MITIGATION PLAN

OAK HILL DAIRY MITIGATION SITE

Gaston County, NC
NCDEQ Contract No. 7867
DMS ID No. 100120

RE: Oak Hill Dairy Mitigation Site
Catawba River Basin 03050102
Gaston County, NC
Response to NCIRT Comments during 30-day Mitigation Plan Review
USACE Action ID No: SAW-2019-00833
DWR Project ID: 7867
NCDMS Project No: 100120

Figure 9 Concept Map
Oak Hill Dairy Mitigation Site
Catawba River Basin 03050102

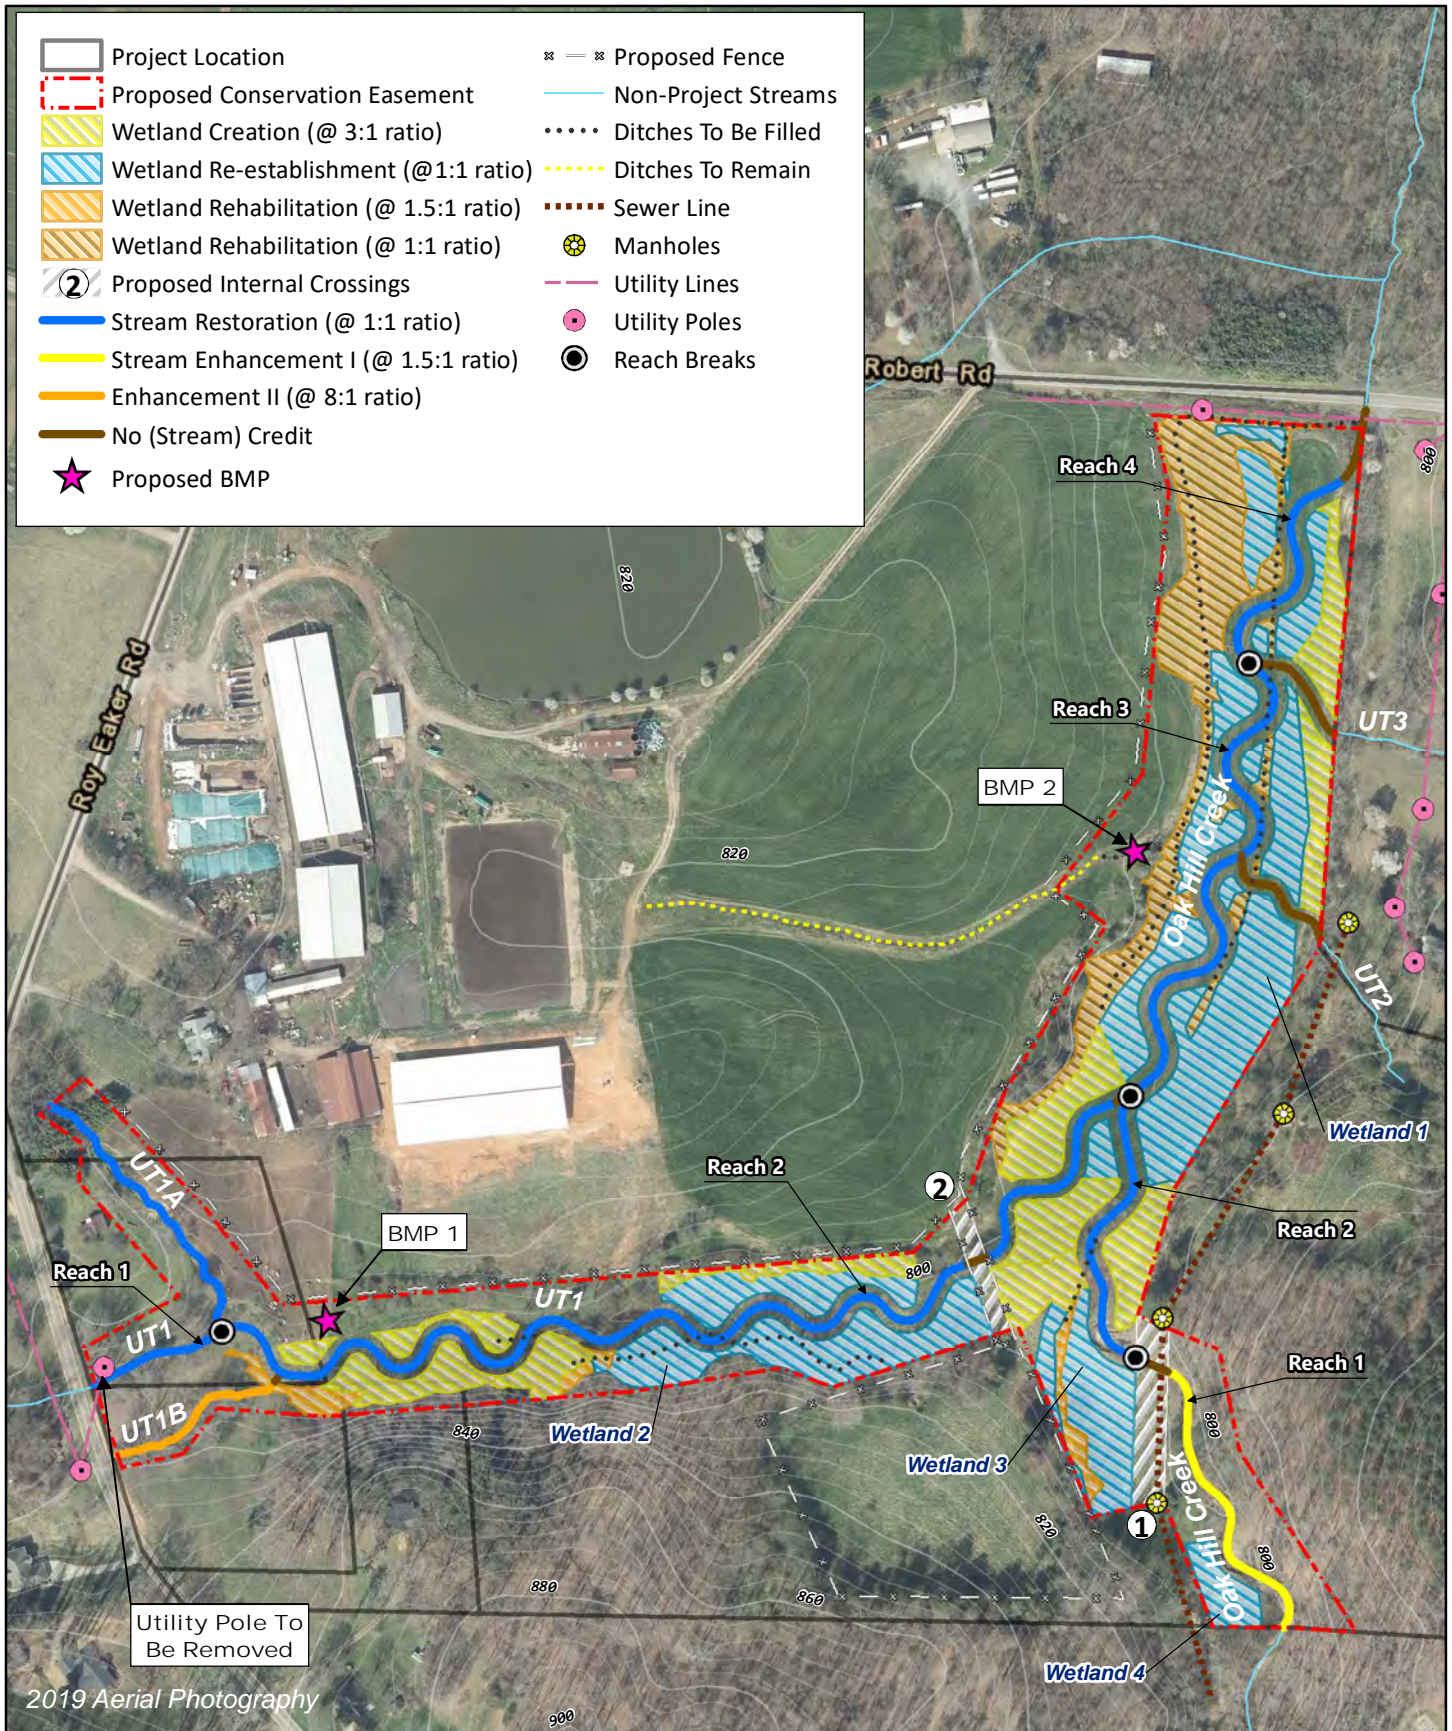
8. *Section 6.7: As a follow-up to our phone conversation February 5, please provide an updated Figure 9 showing the different wetland approaches. Additionally, please label the wetlands to coincide with the Soils Investigation Map in Figure A.*

10. *Figure 9: Please add ratios for wetland re-establishment and creation. Please add ratios for stream work. The ditch legend color differences are not readily apparent on the map.*

Wildlands Response: Wetland approaches have been updated in Figure 9 and they have also been labeled to conform with the Soils Investigation Map in Figure A.

Wildlands Response: Figure 9 has been updated to include: ratios for wetland re-establishment and creation, stream crediting ratios, and revised symbology for ditches proposed to be filled for clarification.

Figure 10 Wetland Grading Depth Map
 Oak Hill Dairy Mitigation Site
 Catawba River Basin 03050102
 Gaston County, NC

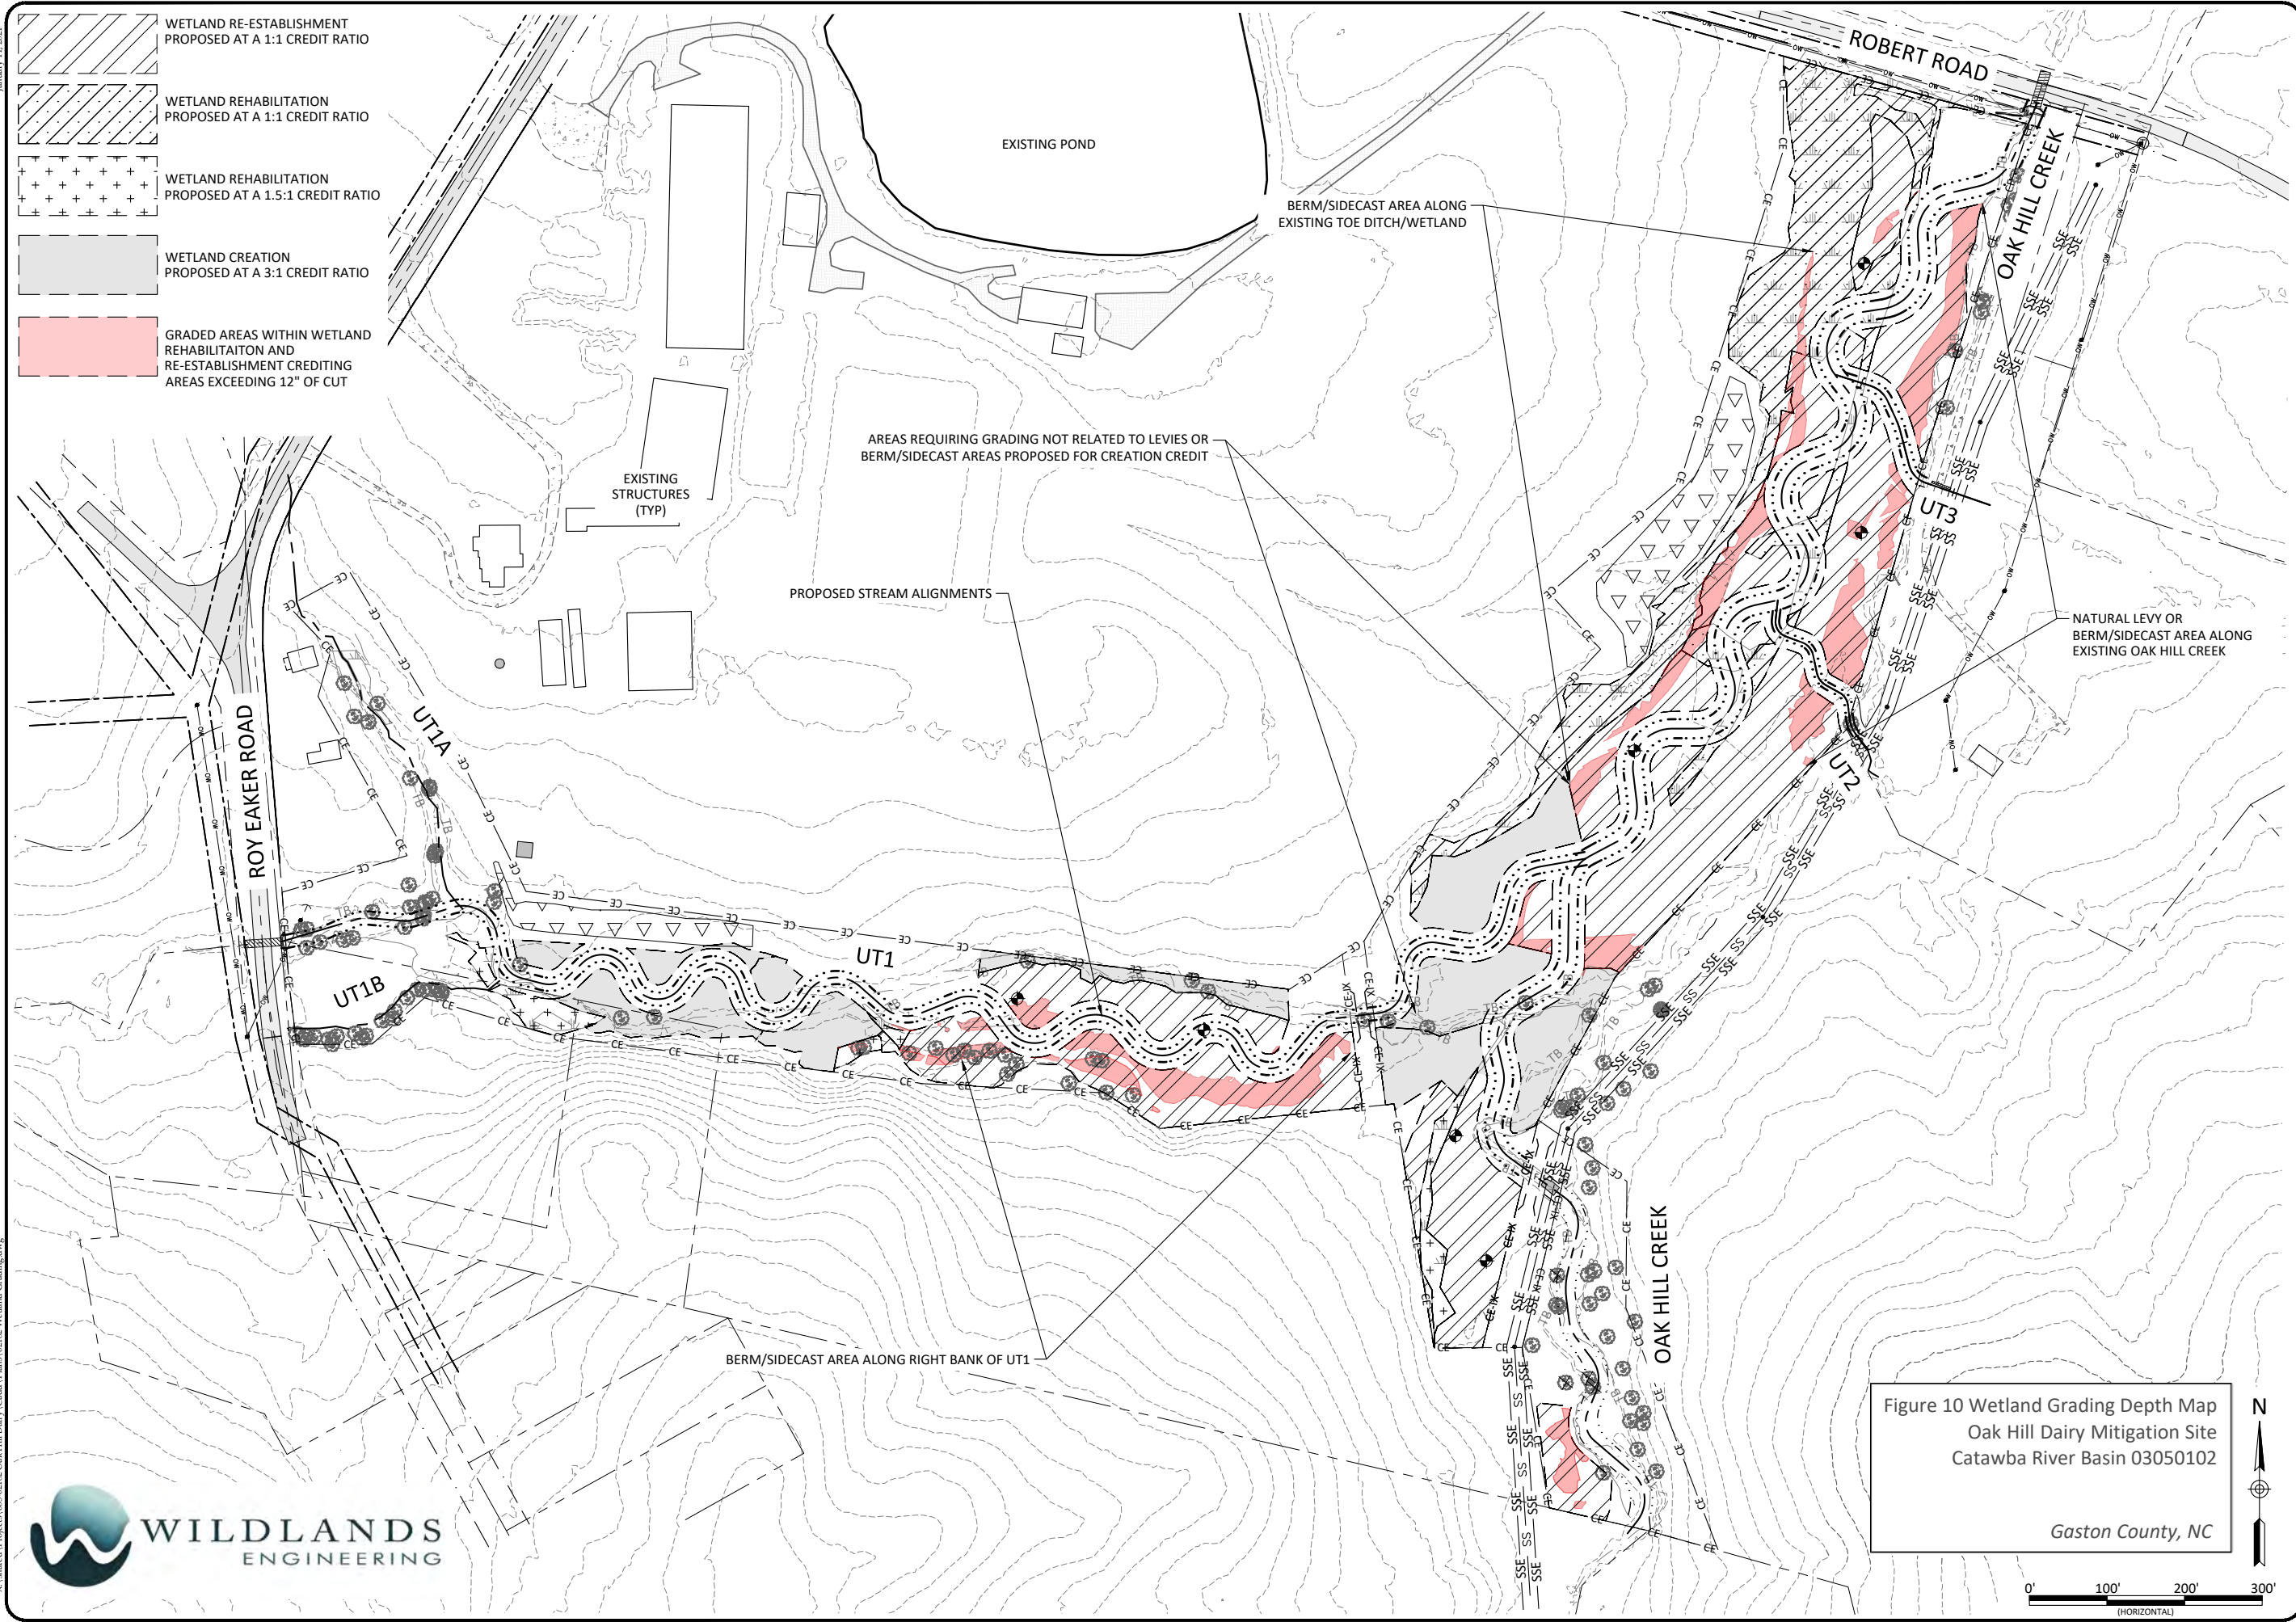
12. *Figure 11: Please correct the Wetland Rehabilitation ratio from 1:5 to 1.5:1.*

Wildlands Response: Figures 10 and 11 have been updated accordingly.
